Town of Hilton Head Island Regular Design Review Board Meeting

AGENDA

DESIGN TEAM/DRB COMMENT SHEET

PROJECT NAME: Smokehouse Outdoor Bar – ALTERATION/ADDITION

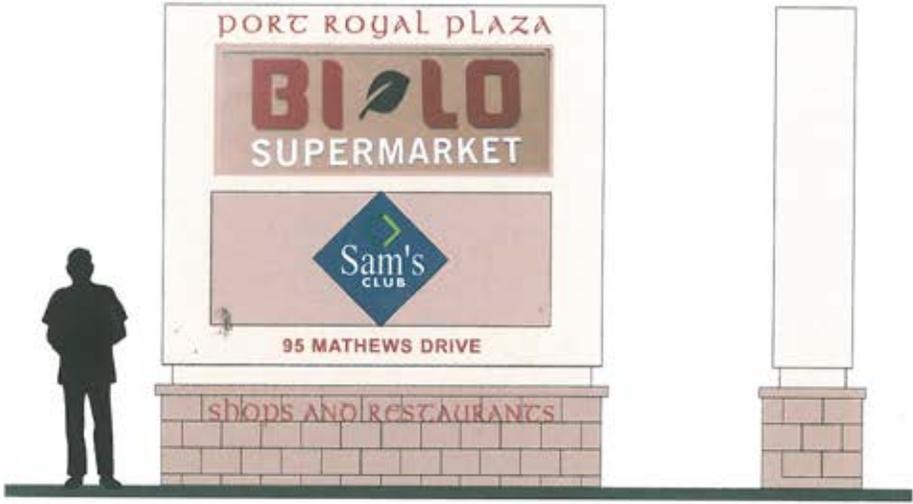
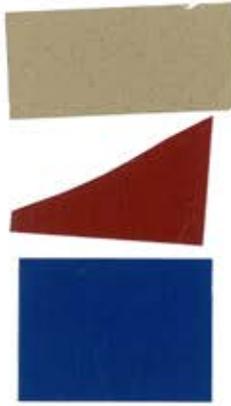
Port Royal Plaza proposes to replace the existing monument signs on William Hilton Parkway and Mathews Drive. The signs are an improvement over the existing signs and will give a clean appearance to the site. The current sign systems allow letters in blue, green, or burgundy. Staff recommends the copy and logos on the proposed monument signs be limited to blue, green, burgundy, and “white” (cool grey 1) and that consideration be given to adding some architectural detail/character to the signs.

Site Plan
S100

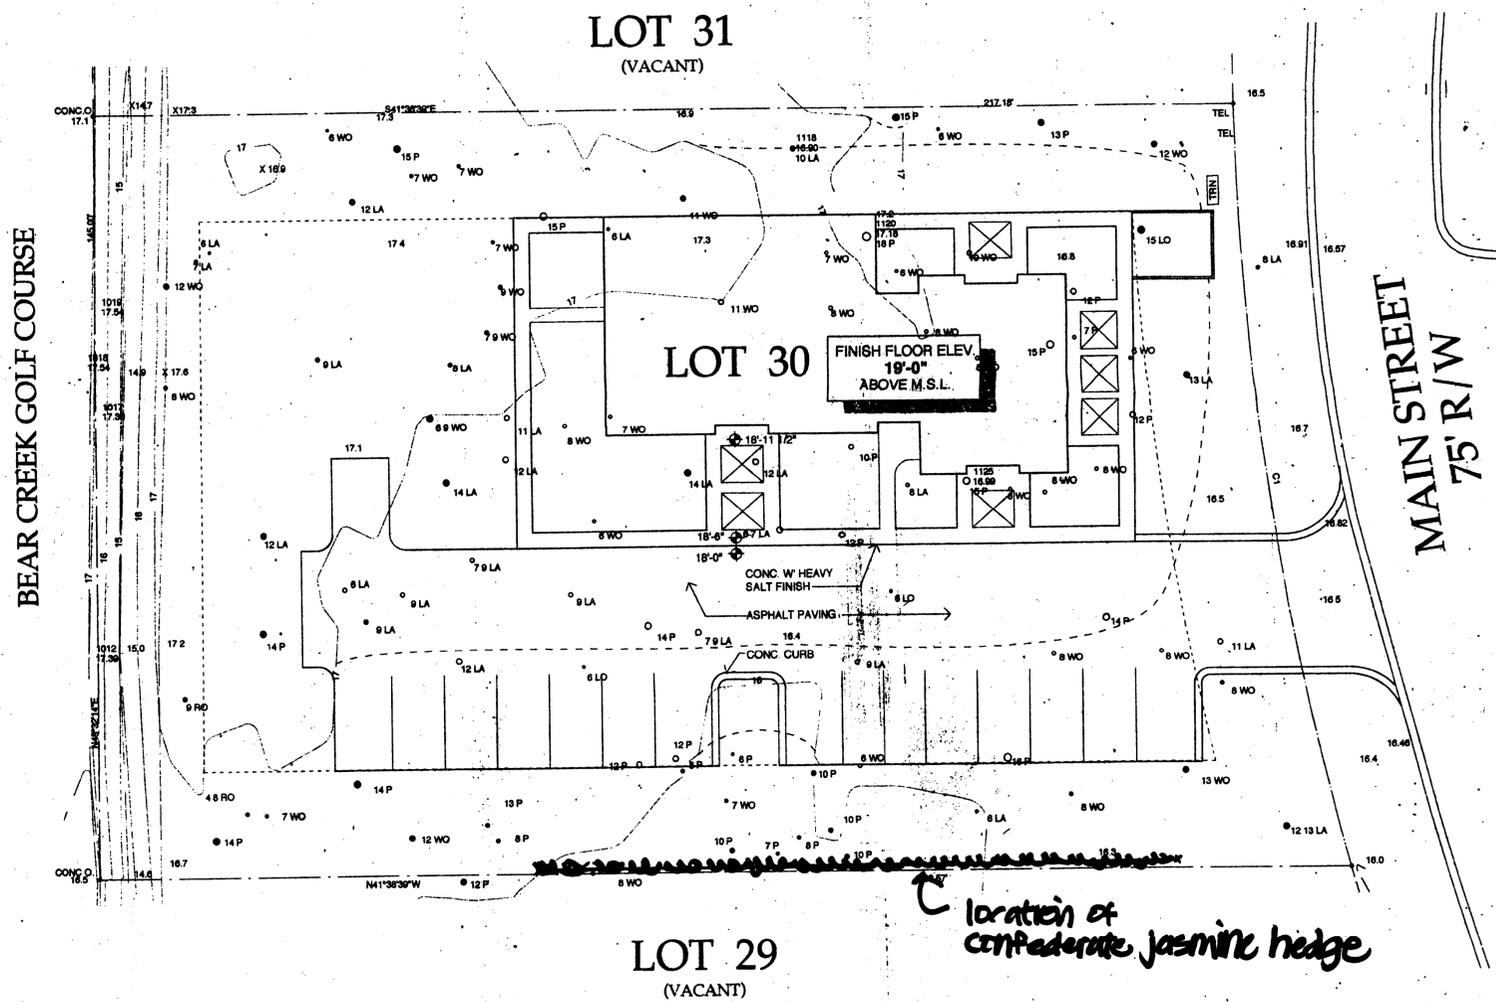
Group 3/Pyramids has installed a fence consisting of 6x6 posts with welded wire mesh, planted with confederate jasmine along their property line. A more decorative fence, or at least a more finished welded wire fence (post with more decorative cap, post stained to match other wood posts on site, framed with top and bottom rail, etc.) would be more in keeping with the site development & landscaping, however the fence is set in the semi-wooded buffer and will not be noticeable once the vines grow up.
